WATER LICENCE INSPECTION FORM

Licensee Lice				Licensee Representative					
Hamlet of Chesterfield Inlet			Douglas Aggark, Megan Lusty (CGS)						
Licence No. / Expiry			Representative's Title						
3BM-CHE1013 (3	0/09/1	.3)		Senior Admir	nistrat	ive Of	ficer		
Date of Inspection				Inspector					
07/07/2014				WRO C. Wilson					
Activities Inspected Camp Roads/Hauling	☐ Drilling ☐ Mining ☐ Construction ☐ Reclamation ☐ Fuel Storage					<u>!</u>			
Conditions: A - Acceptable C - Conc			C - Concern	U - Unacceptable NA – Not Applicable NI – Not Ins			– Not Ins	pected	
Water Use	Condition	Comment	Site Condit	ions	Condition	Comment	Haz/Mat Management	Condition	Comment
Source: FIRST LAKE	Α	1	Water Mana	gement Structures	U	9	Storage	U	7
Intake/Screen	NI	2	Culverts / B	Bridges	NA		Spills	U	8
Flow Measure. Device	U	3	Drainage		NI				
Water Use: Unknown	U	3	Erosion / Sediment		NI				
Recirculation (y /n)	ulation (y /n) NA Signage		Signage		U	10	Administrative

PHOTO 1

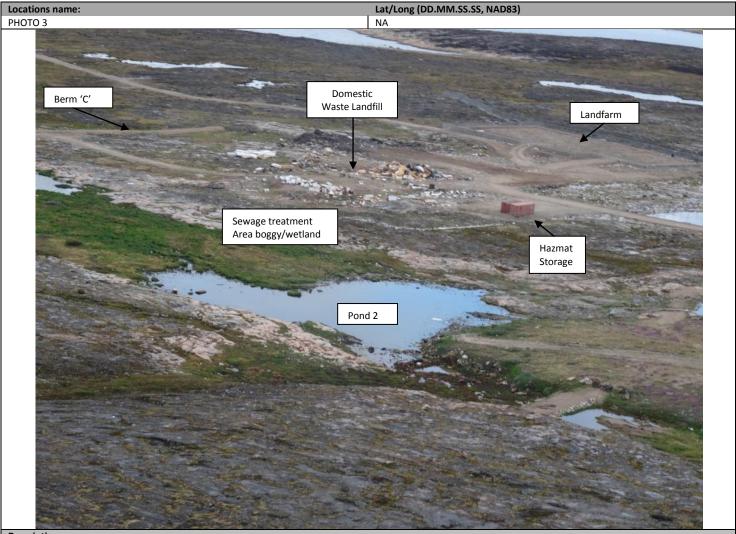
- 2) The raw water intake line has been moved to N 63° 19′ 48.4″, W90° 46′ 18.4″ (photo 1) to avoid additional sediment from arriving in the reservoir. The intake hose was not inspected at this time as it was being repaired. The Hamlet advised the inspector the hose was fitted with two types of screen which helps reduce particulate and debris from entering the reservoir.

Raw water intake location at fish lake. This is where the water meter must be installed to count for the raw water drawn to the reservior.

- The Hamlet will install at the intake pump at First Lake and record the meter volume daily while filling the reservoir. A picture of the meter will be provided to the inspector before September 30th, 2014.
